UNITED STATES OF AMERICA  
NUCLEAR REGULATORY COMMISSION  
before the  
ATOMIC SAFETY AND LICENSING BOARD

In the Matter of )  
 ) Docket Nos. 50-445-OL  
TEXAS UTILITIES ELECTRIC ) 50-446-OL  
COMPANY et al. )  
 )  
(Comanche Peak Steam Electric ) (Application for an  
Station, Units 1 and 2) ) Operating License)  
 )  
 )

AFFIDAVIT OF HOWARD A. LEVIN

1. I am a Vice President of Tenera, L.P., the Third  
Party Organization which prepared the "Piping and Supports  
Discipline Specific Action Plan" ("DSAP IX"), Rev. 2, June 18,  
1987. Tenera also prepared the "Discipline Specific Results  
Report: Piping and Supports," Rev. 1, August 27, 1987, under the  
charter of the Comanche Peak Response Team ("CPRT") Program Plan.  
I was the Review Team Leader with the overall responsibility  
within Tenera for the preparation of both DSAP IX and the  
Discipline Specific Results Report: Piping and Supports. A  
statement of my professional qualifications is attached.

FIGURE 3.2-1  
TYPICAL RICHMOND INSERT/  
TUBE STEEL CONNECTION

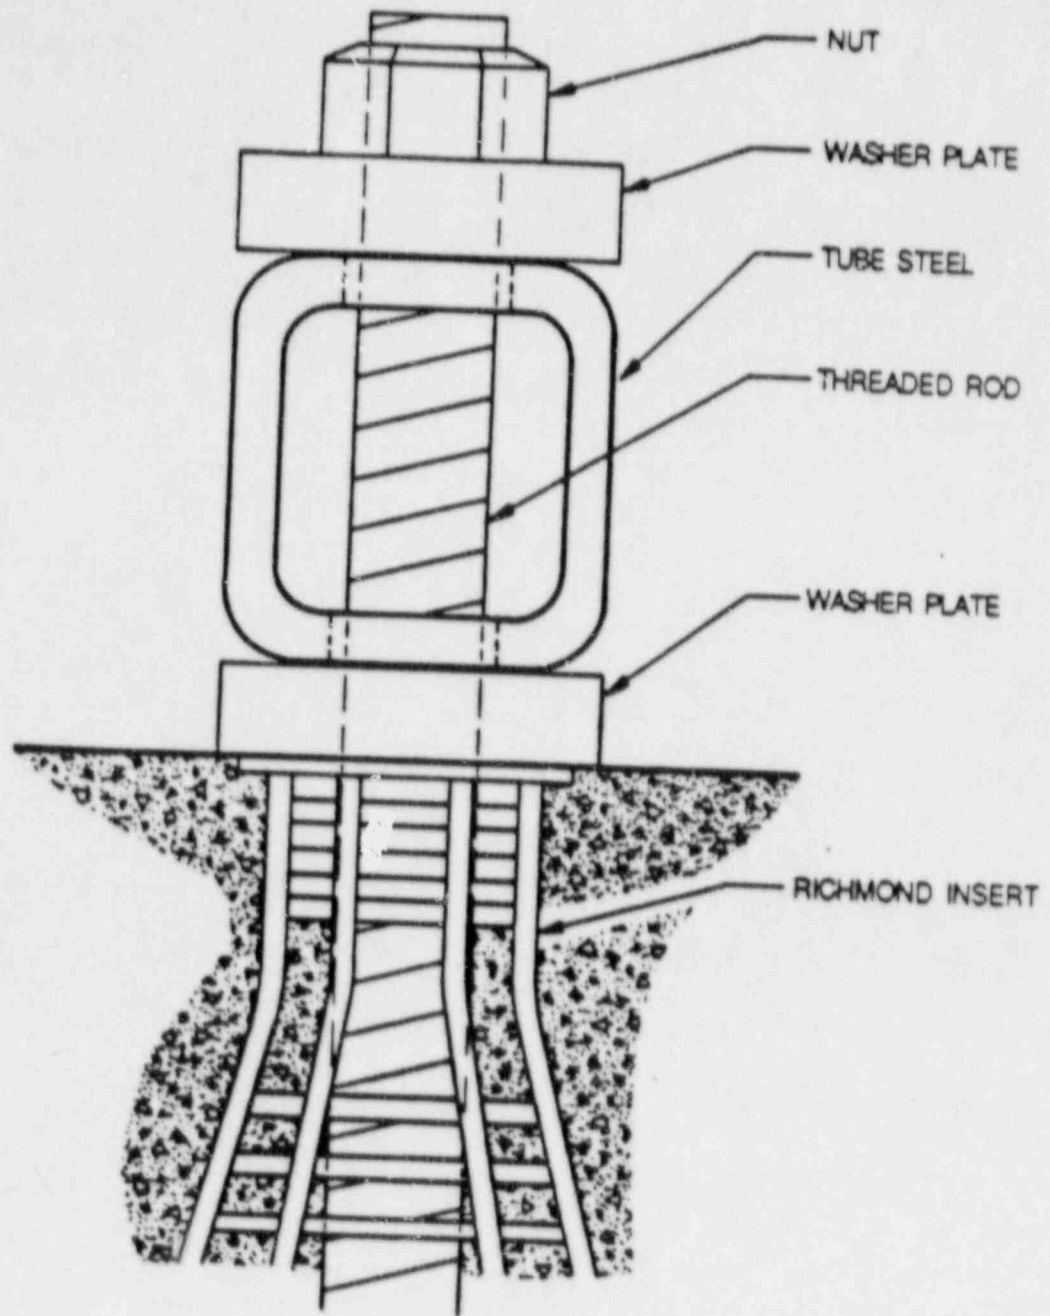
The use of Richmond Inserts in structural tube connections (see FIGURE 3.2-1) has raised concerns generally relating to design allowables, methods used to compute bolt loads in tube connections, and frame modeling and analysis of the insert/tube connection. A more detailed discussion of this issue can be found in Engineering Evaluation DAP-E-P-001. Specific concerns within these areas are the following:

- **Local Stress at Bolt Holes in Tubing** - The local stress at bolt holes in structural tubing was not evaluated. Such stress could cause punching-type failure in the tubing.

- **Fatigue** - Fatigue caused by cyclic loading of the connection was not considered in the design.
- **Improper Use of Richmond Allowables** - Threaded rods/bolts at Richmond Inserts occasionally were unconservatively evaluated because the tension and shear allowables for the insert were used.

- Spacing at Richmond Inserts - Lack of TUGCO structural attachment interface program could result in failure to consider spacing effects of nearby anchors/sleeves in the structural evaluation of inserts.
- Shear Distribution at Richmond Inserts - The threaded rod and hole fit-up tolerances could cause unequal sharing of shear loading from tubing which is anchored by two or more Richmond Inserts.
- LOCA Thermal Expansion of Tube Steel - Under LOCA conditions, thermal expansion of long tubing anchored by two or more Richmond Inserts could produce unacceptably high loads and large deformations in the insert/rod connection.

FIGURE 3.2-2  
SUPPORT STABILITY

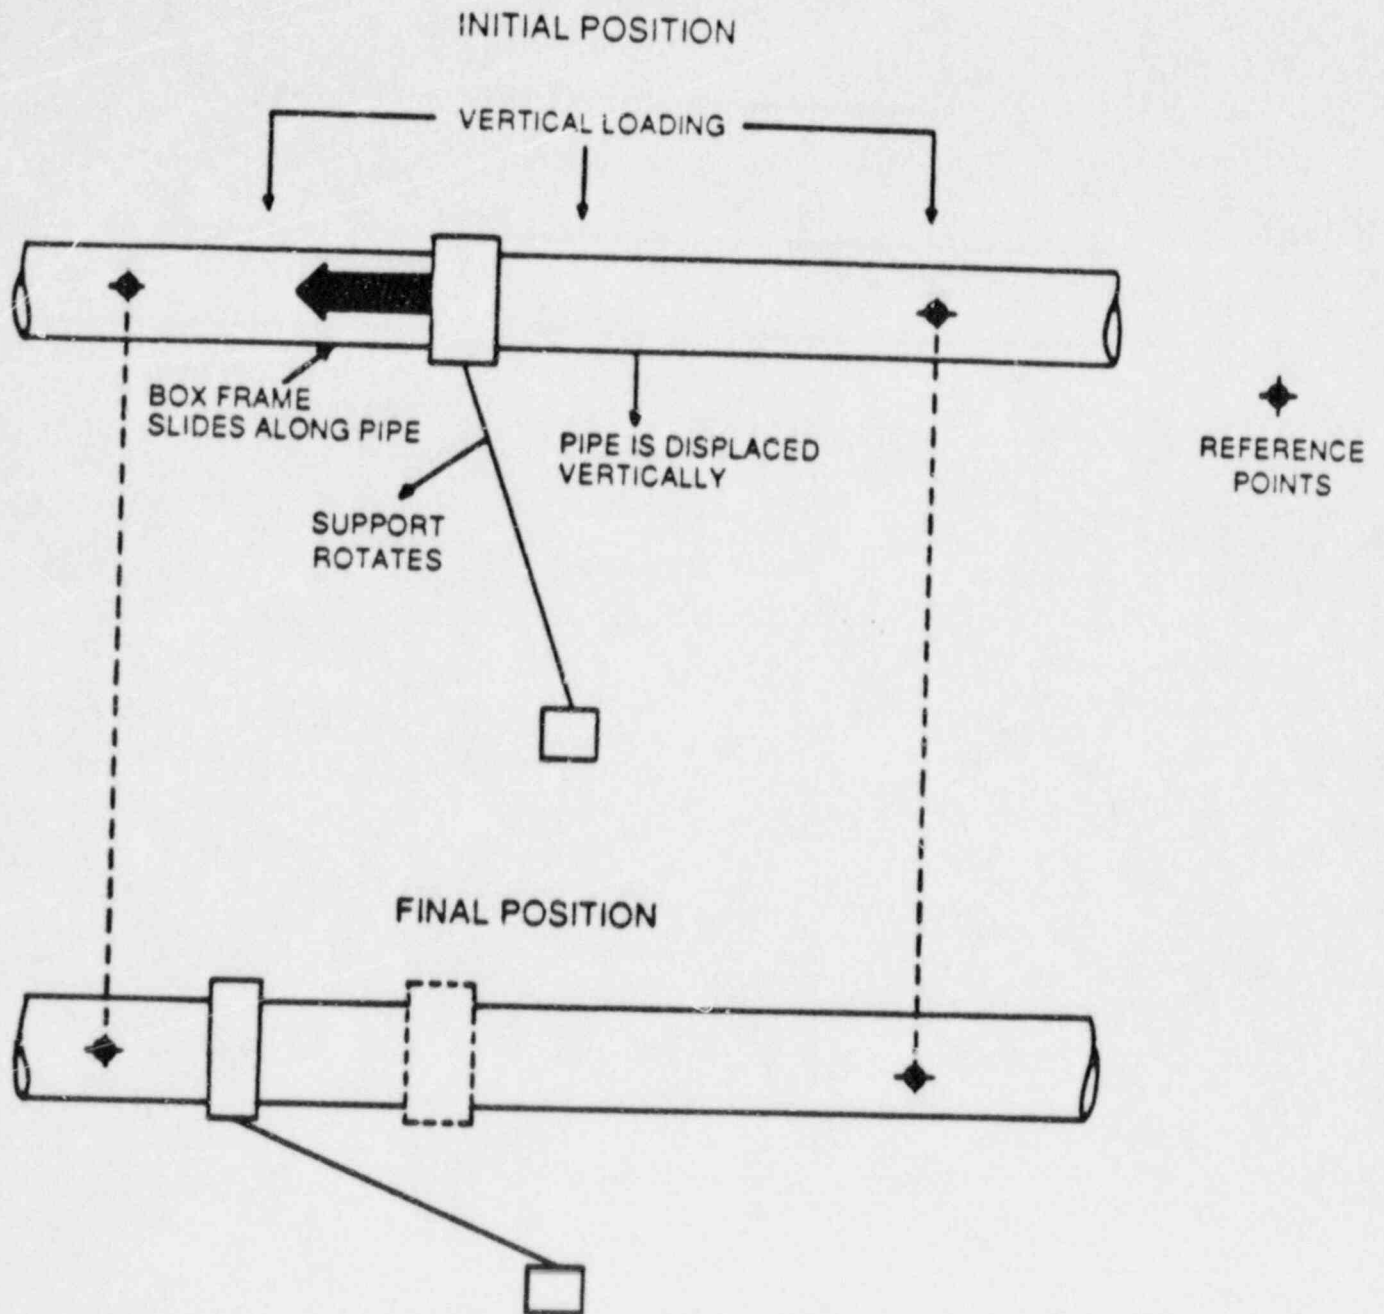
For each of these categories, a displacement mechanism can be postulated that leads to a failure to carry the intended load. The technical issue is whether one can analytically demonstrate that the postulated mechanisms do not occur under the set of loading conditions imposed for the qualification of piping. FIGURE 3.2-2 depicts a postulated displacement wherein a box frame moves along the axis of a pipe. A support which may undergo such displacement is considered unstable because it may not perform as required or as modeled in the analysis.

The approach adopted by SWEC addresses the concern specifically for the types of supports that were previously challenged, and also for every piping analysis, by performing evaluations for stability. The implementation of this process is a significant factor in the determination by the Third Party that the stability issue is comprehensively addressed. The SWEC solutions for

specific support designs provide the basis for determining the adequacy of the approach. SWEC has placed the major emphasis on support removal or redesign. Implementation of the SWEC approach has resulted in elimination of two of the five categories of unstable design. The support categories were treated in the following ways:

FIGURE 3.2-3  
FLARE BEVEL WELD

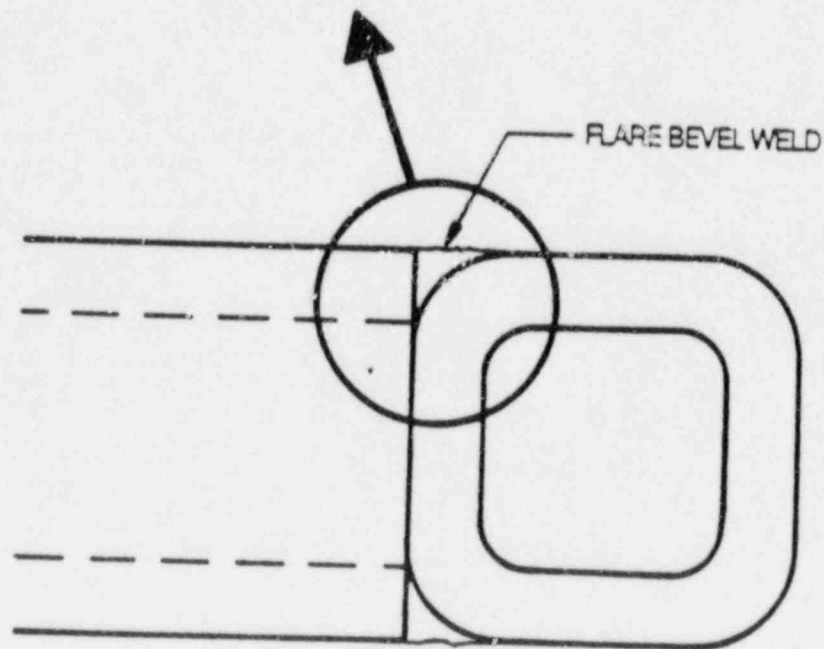
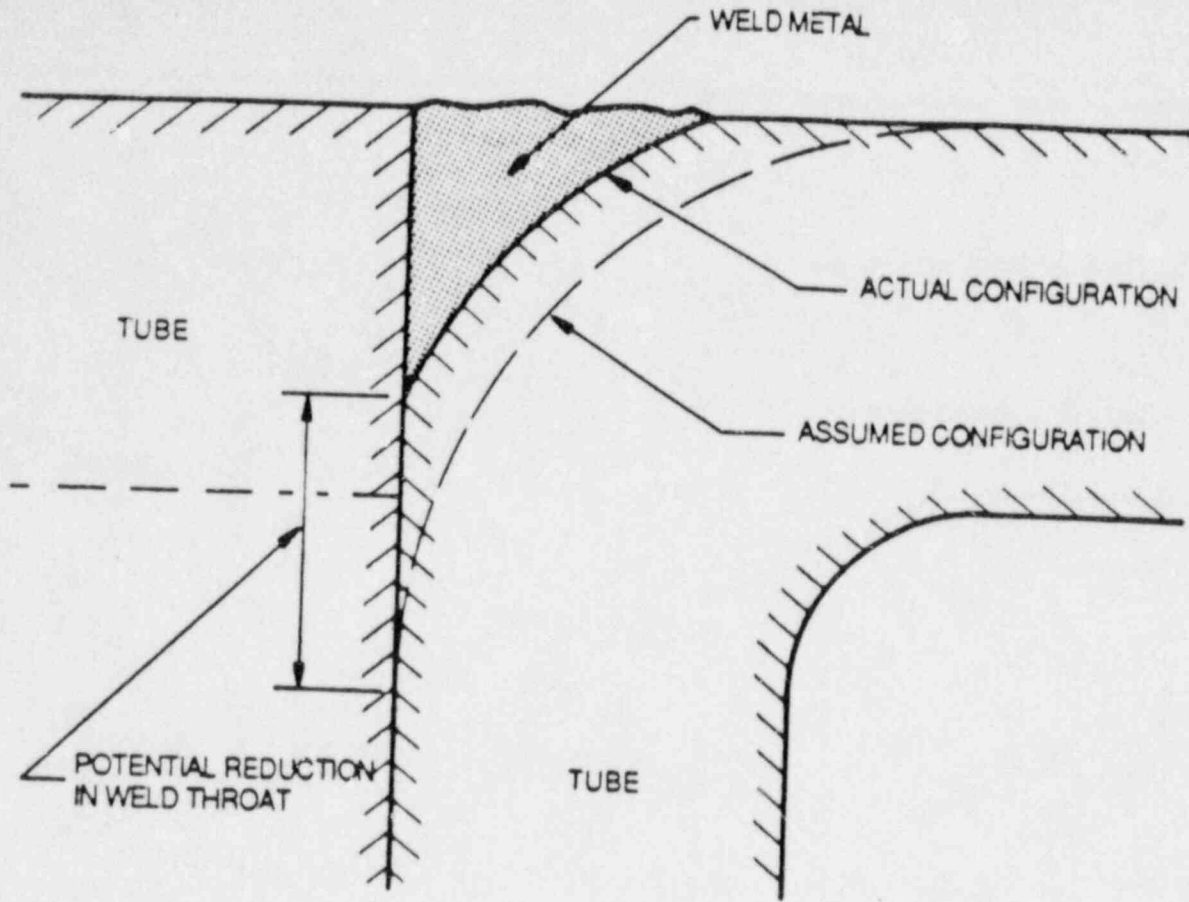
- In the process of sampling tube steel dimensions, a geometric configuration was identified by SWEC that has an effect on the capacity of a flare bevel weld for a matched tube steel connection. FIGURE 3.2-3 depicts the difference between the configuration typically assumed and the actual configuration. As a result of the difference, the opportunity to achieve weld penetration is lessened, which has an adverse effect on weld throat. For such cases the tests performed by SWEC to arrive at a calculation method, i.e.,  $t - 1/8$  inch, are an acceptable means for qualifying the welds.

- To address the concern related to flare bevel welds, SWEC performed tests to establish a basis for the effective weld throat calculation. A sample of installed supports was measured to determine corner radius. This was compared to the assumed AWS D1.1 configuration, i.e., a corner radius of twice the tube steel thickness. See FIGURE 3.2-3 for samples with the AWS configuration which would provide weld penetration. SWEC uses a throat equal to  $t$  minus 1/16 inch where  $t$  is the tube steel thickness in inches. For configurations that were more limiting with respect to weld penetration, specimens were welded and the effective throat measured. This resulted in a SWEC requirement to design welds on 2 x 2 x 1/4 and 2 x 2 x 3/16 inch tube steel using an effective throat equal to  $t$  minus 1/8 inch. These were the only tube steel sizes requiring a reduction of the effective throat, i.e., less than  $t$  minus 1/16 inch.

FIGURE 3.2-4  
ANCHOR BOLT GAPS

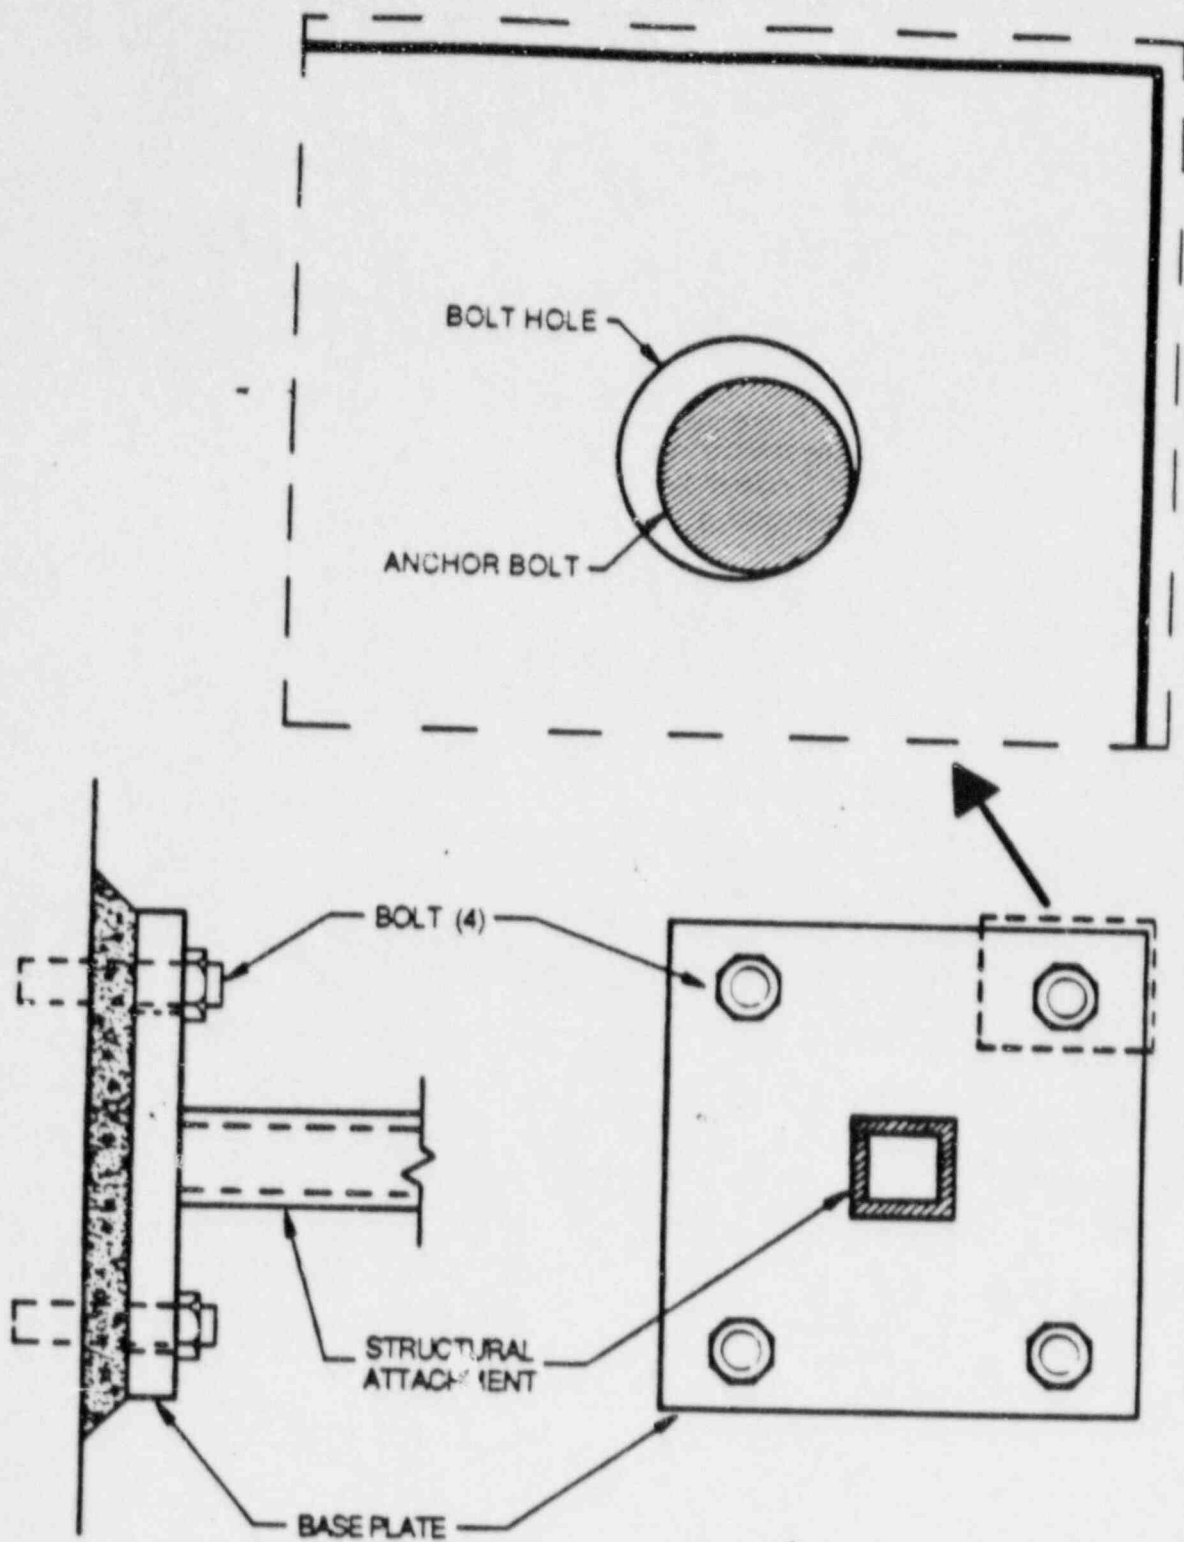
- **Friction vs. Bearing Connections** - Whether base plates fastened with Hilti expansion anchors should be designed as friction or bearing connections. If the connections are bearing connections, there is a question regarding unequal shear load distribution on the anchors and the effect on support stiffness caused by oversized bolt holes (See FIGURE 3.2-4).
- **Anchor Bolt Location Tolerances** - Construction tolerances for anchor bolts or attachment steel installation were not considered in the original design. Neglecting these tolerances may result in unconservatively predicted stresses.
- **Anchorage Embedment** - The embedment lengths on some support sketches do not match those used in the respective calculations.

- **Friction vs. Bearing Connections** - SWEC procedures require that only bearing connections be used in pipe support design. SWEC has adopted Subsection NF-4721, Summer 1985 addenda (Reference 7.23) which defines the allowable bolt hole sizes for such bearing connections.
- **Anchor Bolt Location Tolerances** - In addition to specifying minimum edge distances for holes in base plates, SWEC provides a procedure for verifying the acceptance of as-

built plates that were designed without consideration of possible bolt and attachment location tolerances.
